Order Number:	CCT 0211 4004 GSD2000000020 3	Procurement Folder:	662743
Document Name:	EOI: Building Four Renovations	Reason for Modification:	Change Order No. 2 is issued to increase the contract per the attached documentation.
Document Description:	EOI: Building Four Renovations		
Procurement Type:	Central Contract - Fixed Amt		
Buyer Name:	Melissa Pettrey		
Telephone:	(304) 558-0094		
Email:	melissa.k.pettrey@wv.gov		
Shipping Method:	Best Way	Effective Start Date:	2020-04-24
Free on Board:	FOB Dest, Freight Prepaid	Effective End Date:	2022-04-23

Change Order No. 2

RE: #22010.00 West Virginia Building Four Renovations
Change Order for Additional Services – Programming Modifications

RE: #22010.00 West Virginia Building Four Renovations
Change Order for Additional Services – HVAC Redesign

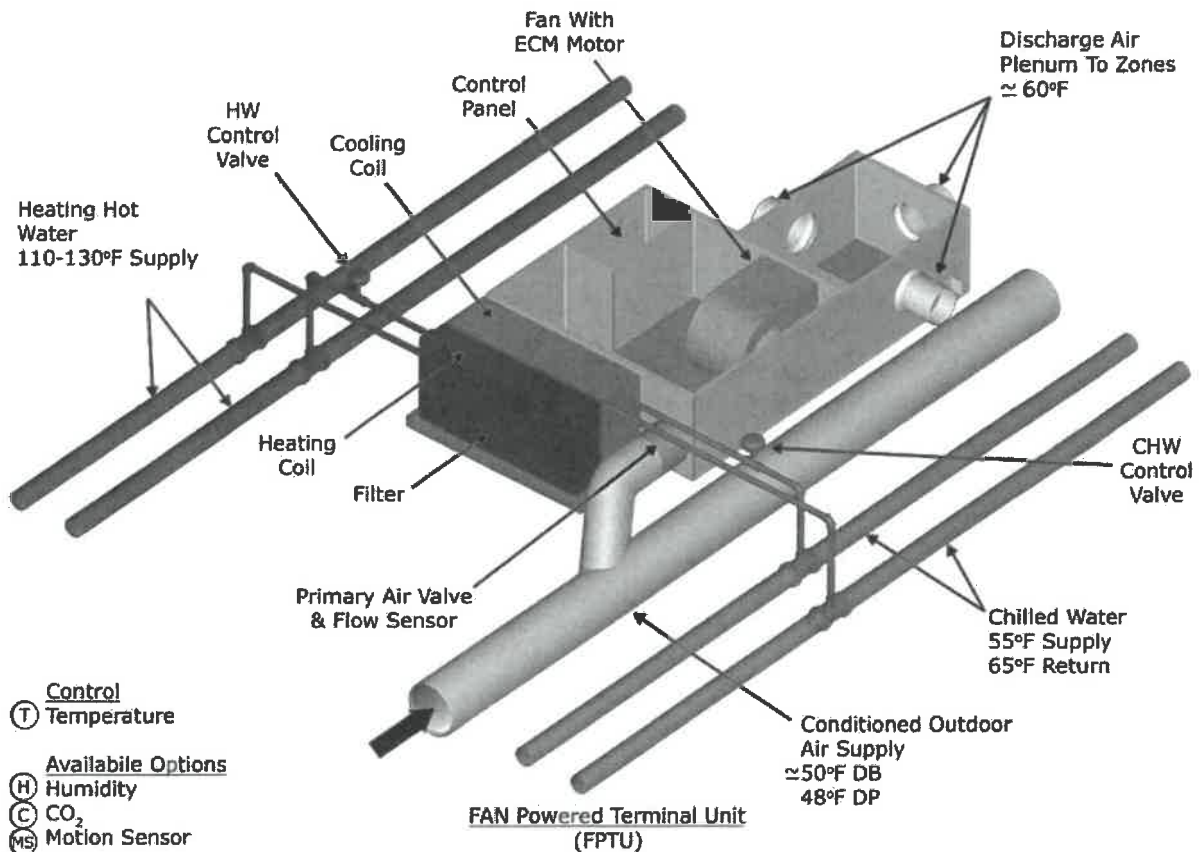
After reviewing the Schematic Design narrative, we would recommend including evaluation of a Dedicated Outside Air System (DOAS) with a sensible cooling only fan powered induction VAV box with reheat where that's applicable terminal unit design. The DOAS primary air inlet delivers ventilation air to the terminal box and handles latent loads in the space. Second, a cooling coil is located on the units' induced air inlet either with or without heating capabilities. A DOAS system provides conditioned outside air ducted directly to space to meet ASHRAE 62 code required ventilation rates which helps ensure sufficient ventilation air is supplied where needed and sized for handling the spaces latent loads. Central AHU's using mixed air which is what is proposed in the SD submission requires careful analysis to ensure the appropriate outdoor air is supplied to the space since air supplied through mixed air is not the same as 100% outside air.

The industry is moving away from large central air systems and moving towards decentralized systems to reduce energy and long-term operating costs. The specific heat for water is much higher than air which allows it to be distributed with less transport energy than can be accomplished with ducted air systems. The reason behind this industry move is to minimize fan energy consumed in the building. Using smaller fans equipped with ECM motor technology helps to maximize diversity savings while using highly efficient motors. This design approach would drastically shrink the two custom AHU's located in the indoor mechanical space to much smaller unit(s) dedicated to only the required outside air for the building. By selecting a DOAS unit approach that is specifically designed to treat outside air and dehumidification most efficiently you can minimize long term energy and operating costs. The other benefit of a central DOAS unit would be the overall reduction of duct sizes throughout the facility. If the central DOAS system is sized properly it could also limit the amount of condensate on the terminal unit coils and allow for some downsizing of the terminal units. This HVAC system type is supported by ASHRAE as a High-Performance Building Design. This type of system may also impact the need for the

proposed 5th floor VRF temporary system which assists in cost savings if phasing issues can be addressed.

The concept diagram above is shown just to convey the concept. The heating coil as an example could be located on the discharge side of the fan powered box when heating is necessary instead of the return side. The primary air valve is from the DOAS system.
